PENNSYLVANIA ELECTRIC COMPANY
THREE MILE ISLAND NUCLEAR STATION UNIT 1

Operating License No. DPR-50
Docket No. 50-289
Technical Specification Change Request No. 31

Technical Specification Change Request No. 31

FIGURE 2.3-1

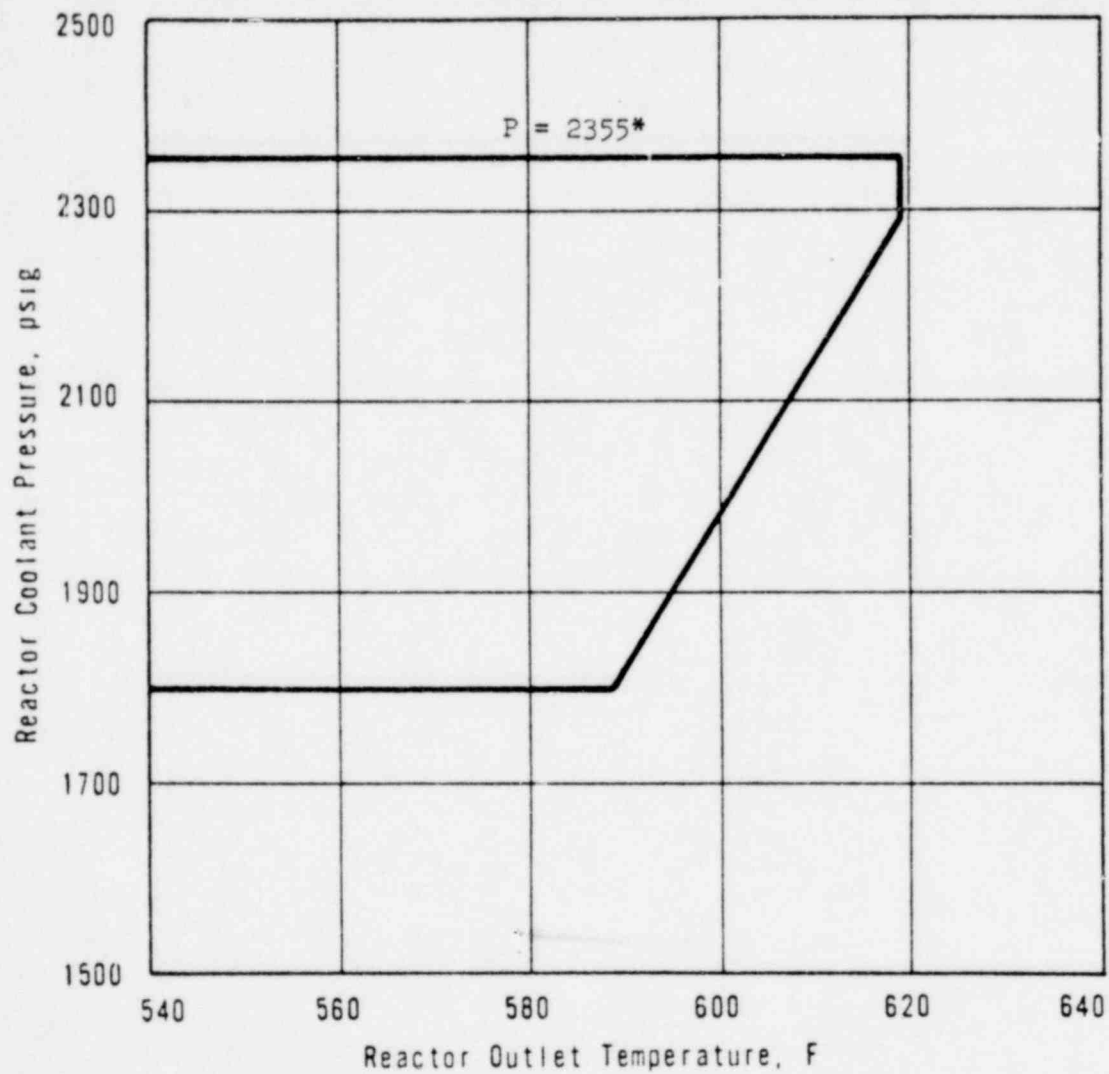
During a startup accident from low power or a slow rod withdrawal from high power, the system high pressure trip set point is reached before the nuclear overpower trip set point. The trip setting limit shown in Figure 2.3-1 for high reactor coolant system pressure (2355*psig) has been established to maintain the system pressure below the safety limit (2750 psig) for any design transient.

- 2.3.1 The reactor protection system trip setting limits and the permissible bypasses for the instrument channels shall be as stated in Table 2.3-1 and Figure 2.3-2.
- 2.3.2 For the 24 hour period prior to shutdown for refueling the high pressure trip setpoint may be increased to 2405 psig provided that the following precautions are taken during this period.
 - a. If pressurizer level exceeds 315 inches as indicated by the high-high level alarm, the reactor shall be manually tripped.
 - b. If the reactor drain tank pressure exceeds 15 psig, the reactor shall be manually tripped.

* Except as specified in 2.3.2
